Department of **Biodiversity,
Conservation and Attractions**

DETERMINATION OF DEVELOPMENT APPLICATION

FILE NUMBER : 2017/1509
APPLICANT : Edge Holdings No. 3 (Edge Visionary Living)
AGENT'S ADDRESS :

PROPOSAL	: Establishment of a stormwater drainage swale and associated foreshore stabilisation and revegetation works
LOCATION	: Lot 558 on Diagram 91571 and Lot 559 on Diagram 91572 and Lot 302 on Plan 47452 (River Reserve 48325) adjacent to Lot 603 Riversdale Road, Rivervale
APPLICANT	: Edge Holdings No. 3 (Edge Visionary Living)
LANDOWNER	: Western Australian Planning Commission (Lot 558 on Diagram 91571 and Lot 559 on Diagram 91572) and Swan River Trust (River Reserve 48325)
LOCAL GOVERNMENT	: City of Belmont
MRS CLASSIFICATION	: Parks and Recreation and Waterways
DECISION TYPE	: Part 5, <i>Swan and Canning Rivers Management Act 2006</i> – Ministerial Determination
ATTACHMENTS	: <ol style="list-style-type: none">1. Location map2. Aerial photo of subject land3. Development approval for the Residential Development4. Existing Site Plan and Concept Landscaping Plan5. Concept Landscaping Plan with Pedestrian Access Ramp6. Concept Drainage Swale Design

VANTAGE - RIVER ACCESS PATH
LOTS 558 & 559 RIVERSDALE ROAD, RIVERVALE
EDGE VISIONARY LIVING

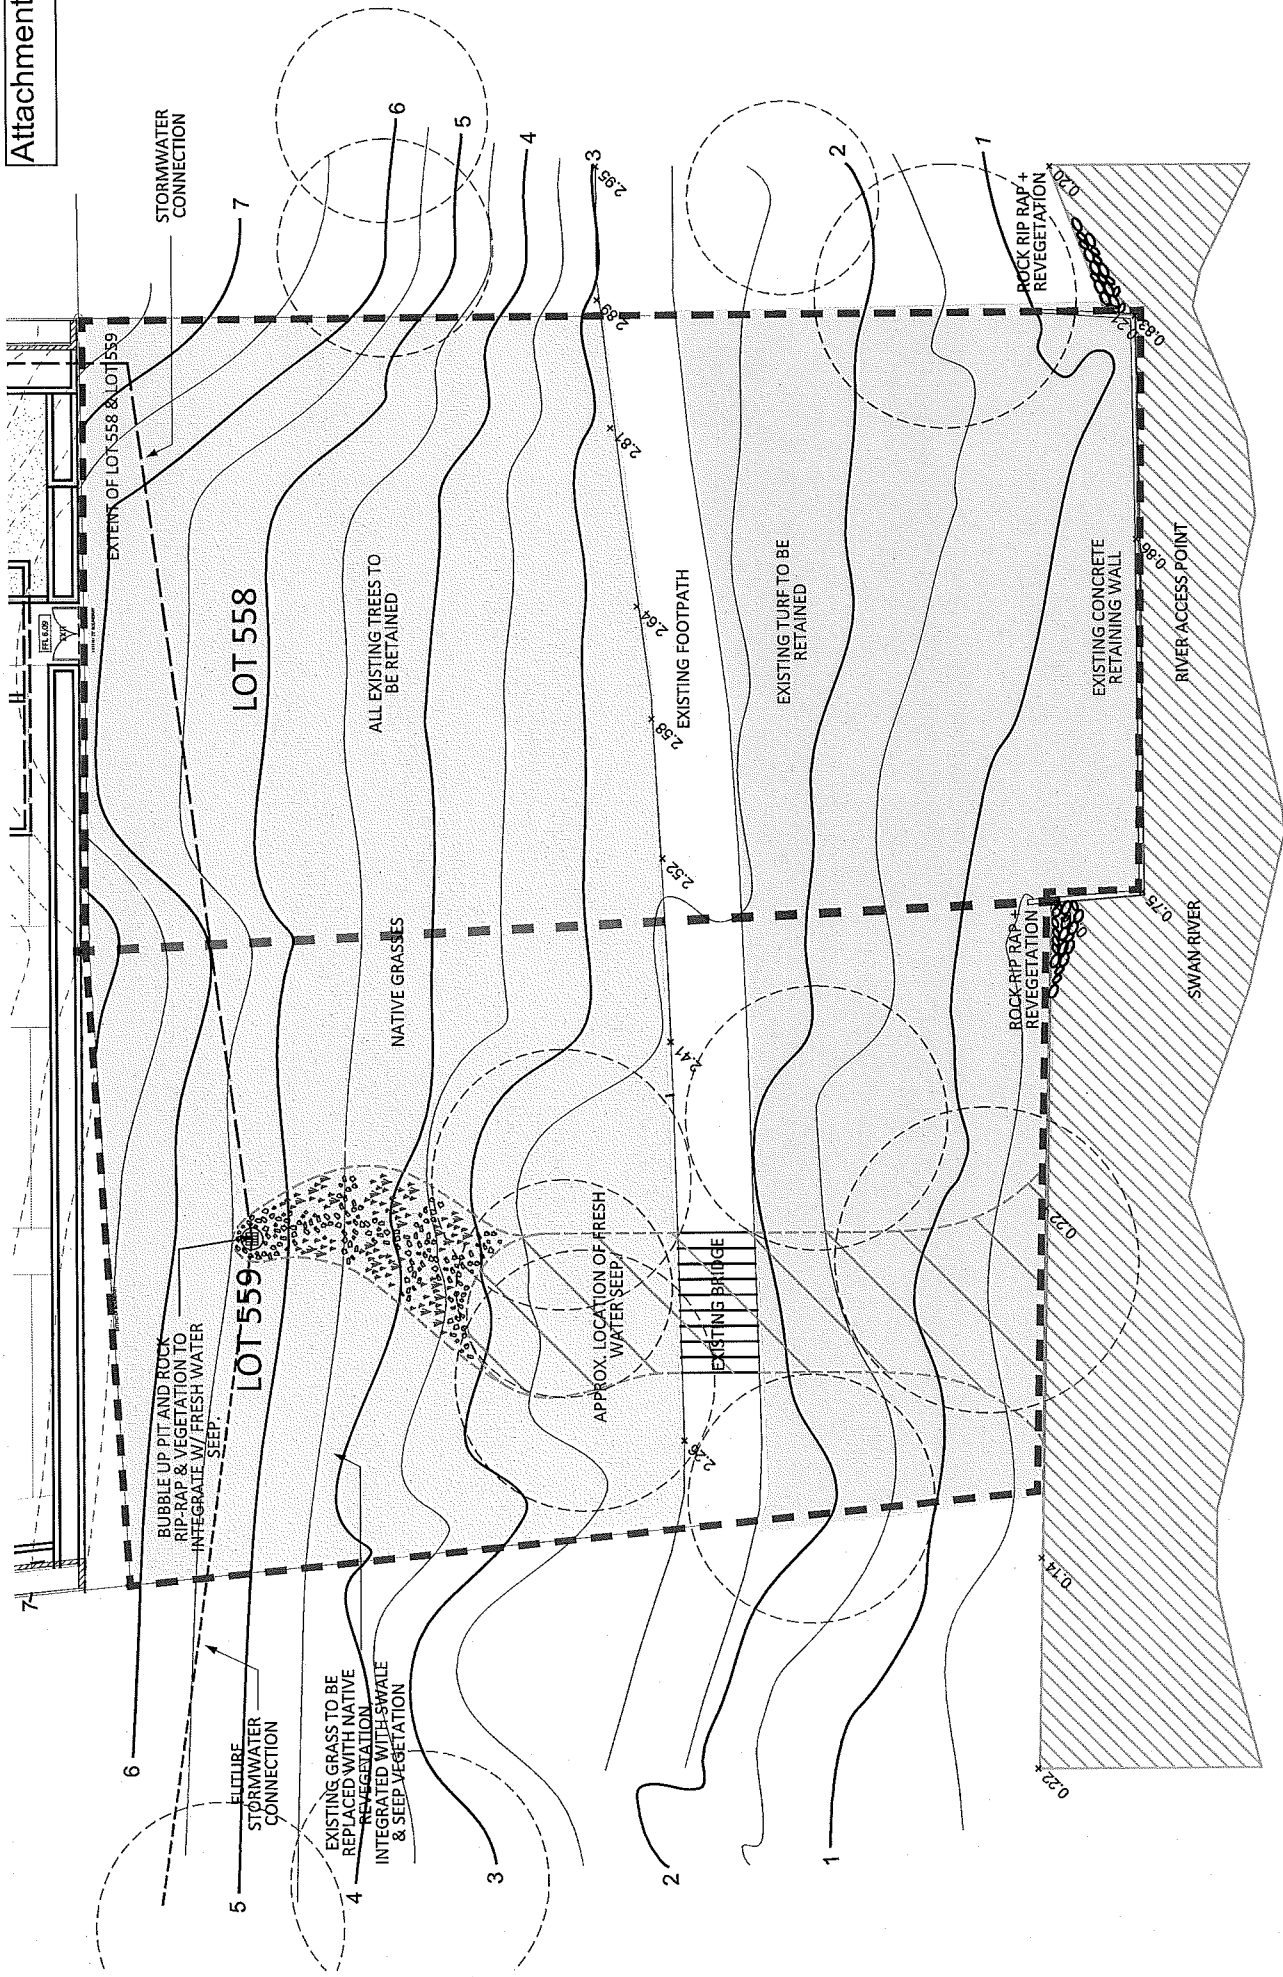
- 6.7 The plans submitted with the Part 5 Development Application initially included a proposed access ramp (approx. 18m) to facilitate access for future residents to the foreshore reserve (Lots 558 and 559). The proposed access ramp was to connect with the existing pathway at the lower section of the foreshore reserve.

- 6.10 The applicant has subsequently removed the access ramp from its proposed plans, including landscaping features (i.e. seating) associated with the structure.

Vantage Riverside Apartments Stormwater Discharge Revised Option – Vegetated infiltration swale

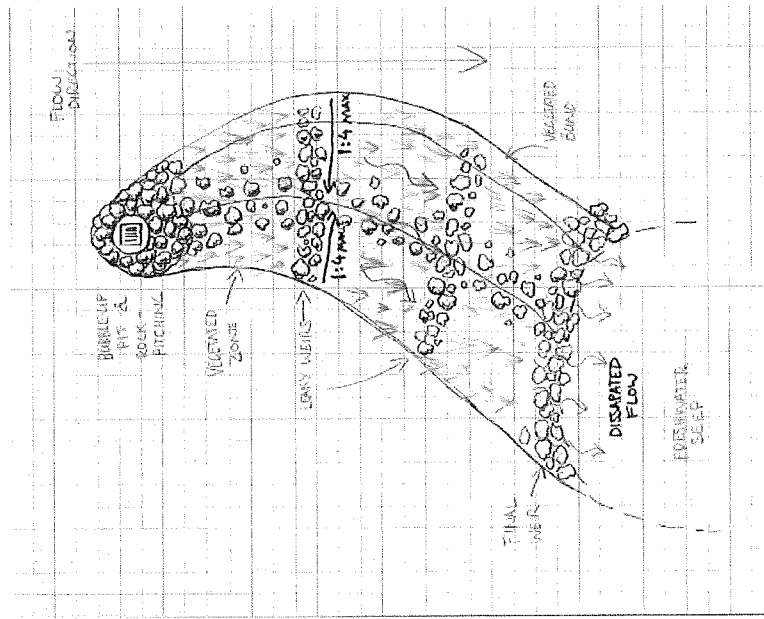
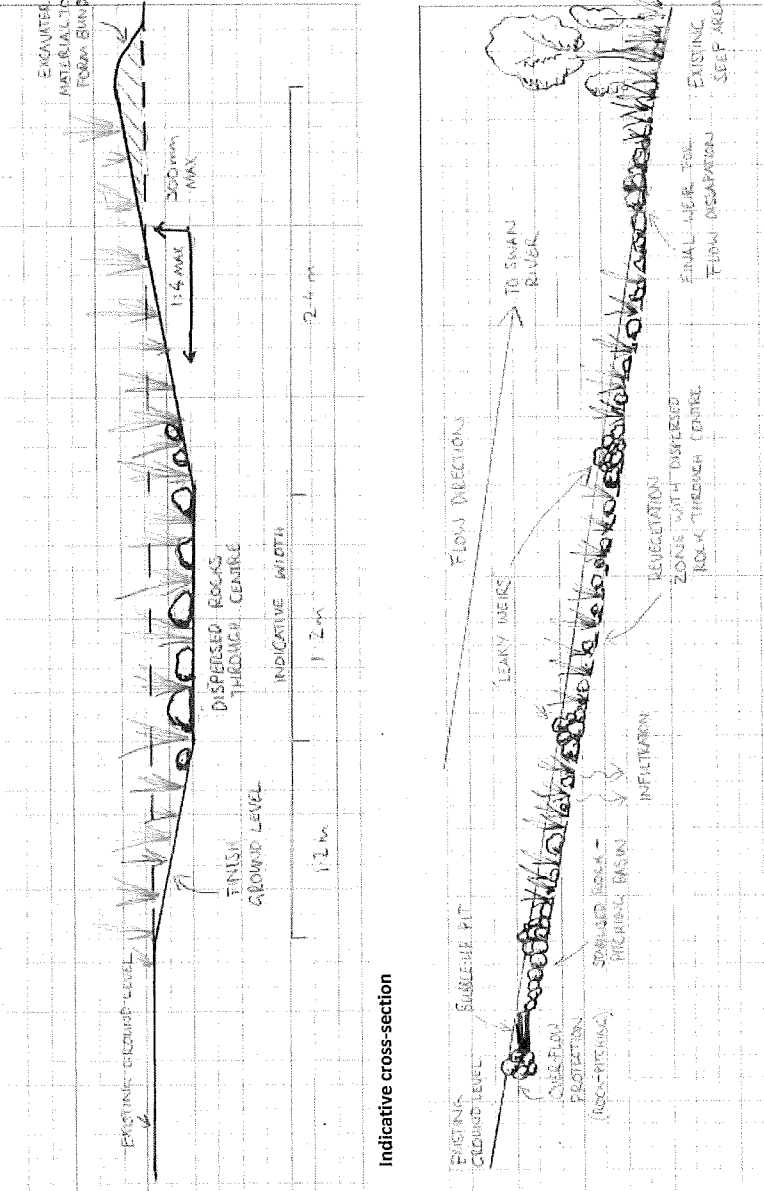
- d. Further details of the foreshore treatment method to stabilise the lower foreshore (i.e. soil infill, rock rip-rap and revegetation).
 - e. Further details of the drainage swale and bubble up-pit, including erosion and scour protection method.

4. In relation to **Condition 5**, the detailed engineering design/drawings, including cross-sectional drawings, of the drainage swale and bubble-up pit, foreshore stabilisation works and any landscaping features are to be provided, showing the exact design and location of the structures.
